Office Action Summary	Application No. 10/582,736	Applicant(s) UDO ET AL.	
	Examiner JENINE M. PAGAN	Art Unit 3728

DETAILED ACTION

1. In view of the Appeal Brief filed on 12/6/2010 and 10/18/2010, PROSECUTION IS HEREBY REOPENED. New grounds of rejection are set forth below.

FIG. 4

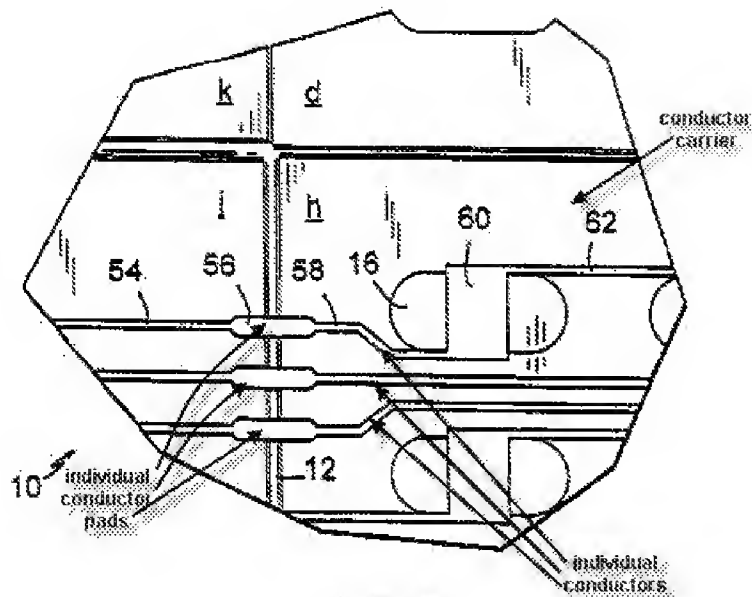
Claim 1: Ehrensvard discloses a blister package with an arrangement with a blister package 40 and a conductor carrier (see figure above) connected to it, wherein openings in the conductor carrier are directed toward pockets of the blister package, and wherein, upon removal of a tablet 44 from a pocket, a

sealing film 16 of the blister package sealing the pocket must be separated, and the tablet 44 is removable through an opening assigned to it, the improvement wherein the openings are formed by stamped lines (see figure above) positioned within the conductor carrier (58/60/62)/see figure above that surround each of the pockets in a ring shape, and that are interrupted by at least two bridge parts 17/19 by means of which a covering, separated by the stamped line (see figure above) out of the conductor carrier and covering the pocket, is connected with the conductor carrier (see figure above); wherein the bridge parts 17/19 are so distributed about the periphery of the stamped line that, when a tablet 44 is pressed out from a pocket, at least one bridge part is broken; and wherein the conductor carrier includes individual conductors (58/60/62) each of which extends from an individual connecting pad 56 over at least the one bridge part 17/19 that is severed upon tablet removal. (Col 3:63-4:13 Fig. 4 and 5)

Claim 4: Ehrensvar discloses the stamped lines (see figure above) have a shape selected from the group consisting of an oval.

Claim 5: Ehrensvar discloses the bridge parts 17/19 is positioned diametrically opposite each other about the circumference of the stamped line (see figure above), and wherein the individual conductor (58/60/62) associated therewith extends over both bridge parts 17/19.

Claim 6: Ehrensvar discloses the two bridge parts 17/19 each lie along the direction of the longer extension of the stamped line (see figure above).

Claim 7: Ehrensvard discloses the individual conductor (58/60/62) extends over the first and the additional bridge parts 17/19.

Claim 9: Ehrensvard discloses the conductor carrier (see figure above) includes the individual conductors (58/60/62) on the side facing away from the blister package 40, and is attached to the side facing toward the blister package 40 by means of the sealing film 16 of the blister package.

FIG. 5

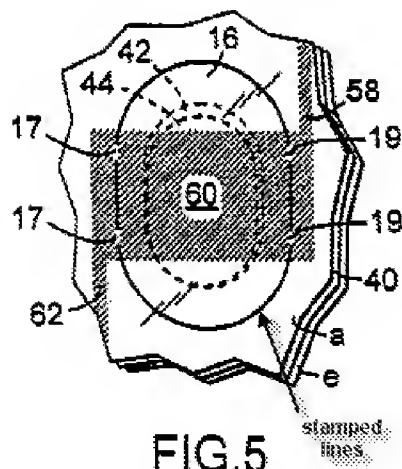
Claim 10: Ehrensvard discloses the conductor carrier (see figure above) is at least partially provided with an electrically insulating protective 90 on its side facing away from the blister package that covers at least the individual conductors and a common conductor. (Col 2:57-67, 3:63-4:13 Fig. 5)

Claim 11: Ehrensvard discloses the conductor carrier (see figure above) includes the individual conductors (58/60/62) on its side facing toward the blister package 40, and that the side of the conductor carrier facing toward the blister package is provided with an electrically insulating layer 90 covering the individual conductors (58/60/62), and wherein the side of the electrically insulating layer 90 facing toward the blister package is connected with the sealing film 16 of the blister package. (Col 2:57-67, 3:63-4:13 Fig. 5)

Claim 12: Ehrensvard discloses the electrically insulating layer 90 is provided with an adhesive layer that may be connected with the sealing film 16 of the blister package 40. (Col 2:57-67)
